Peach Bottom Atomic Power Station, Units 2 and 3
Renewed Facility Operating License Nos. DPR-44 and DPR-56
NRC Docket Nos. 50-277 and 50-278

Subject: Response to Request for Additional Information
Application to Adopt 10 CFR 50.69, "Risk-informed categorization and
treatment of structures, systems, and components for nuclear power plants"

**Response to Request for Additional Information
Application to Adopt 10 CFR 50.69, "Risk-informed categorization and treatment
of structures, systems, and components for nuclear power plants"**

Figure 9-1: Categorization Process Overview

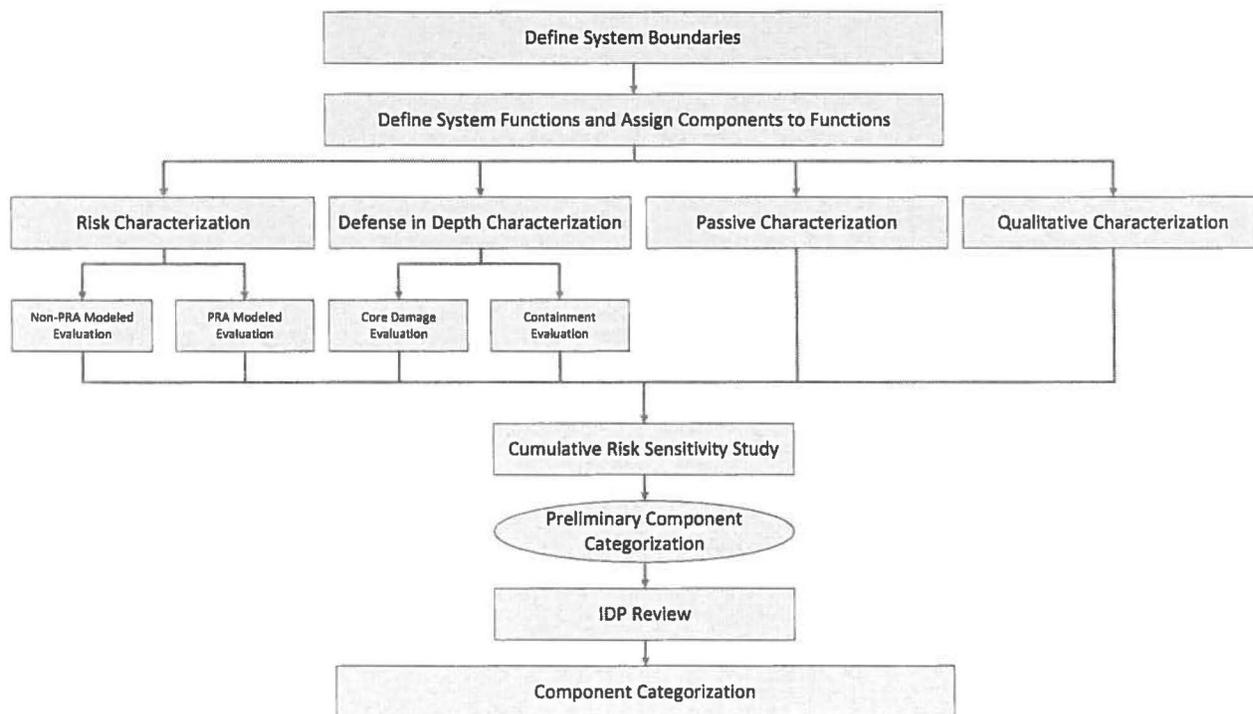
Section 50.69(b)(2)(i) requires that a licensee's application contain a description of the process for SSC categorization. The discussion in Section 3.1.1 of the LAR does not provide enough information for the NRC staff to clearly understand the sequence of evaluations in the categorization process, what information the licensee will develop and use, and what guidance the licensee will follow for the Integrated Decision-making Panel (IDP) decision-making process during the categorization of each system. Information on the training and expertise of the IDP team is provided in the LAR and need not be repeated in response to this RAI. Provide the following:

- v. The input from the passive categorization methodology.
- b. In description to item (a) above, please clarify the difference between "preliminary high-safety significance (HSS)" and "assigned HSS" and identify which inputs can, and which cannot, be changed from preliminary HSS to low-safety significance (LSS) by the IDP. Confirm that the proposed approach is consistent with the guidance in NEI 00-04, as endorsed by RG 1.201.

- c. In description to item (a) above, please clarify which steps of the process are performed at the function level and which steps are performed at the component level. Describe how the categorization of the component impacts the categorization of the function, and vice-versa. Describe instances in which the final safety significance of the function would differ from the safety significance of the component(s) that support the function, and confirm that the proposed approach is consistent with the guidance in NEI 00-04 as endorsed by RG 1.201.

Categorization of SSCs will be completed per the NEI 00-04 process, as endorsed by RG 1.201, which includes the determination of safety significance through the various elements identified above. The results of these elements are used as inputs to arrive at a preliminary component categorization (i.e., High Safety Significant (HSS) or Low Safety Significant (LSS)) that is presented to the Integrated Decision-Making Panel (IDP). Note: the term "preliminary HSS or LSS" is synonymous with the NEI 00-04 term "candidate HSS or LSS." A component or function is preliminarily categorized as HSS if any element of the process results in a preliminary HSS determination in accordance with Table 1 below. The safety significance determination of each element, identified above, is independent of each other and therefore the sequence of the elements does not impact the resulting preliminary categorization of each component or function. Consistent with NEI 00-04, the categorization of a component or function will only be "preliminary" until it has been confirmed by the IDP. Once the IDP confirms that the categorization process was followed appropriately, the final Risk Informed Safety Class (RISC) category can be assigned.

The IDP may direct and approve detailed categorization of components in accordance with NEI 00-04, Section 10.2. The IDP may always elect to change a preliminary LSS component or function to HSS; however, the ability to change component categorization from preliminary HSS to LSS is limited. This ability is only available to the IDP for select process steps as described in NEI 00-04 and endorsed by RG 1.201. Table 1 below summarizes these IDP limitations in NEI 00-04. The steps of the process are performed at either the function level, component level, or both. This is also summarized in Table 1. A component is assigned its final RISC category upon approval by the IDP.
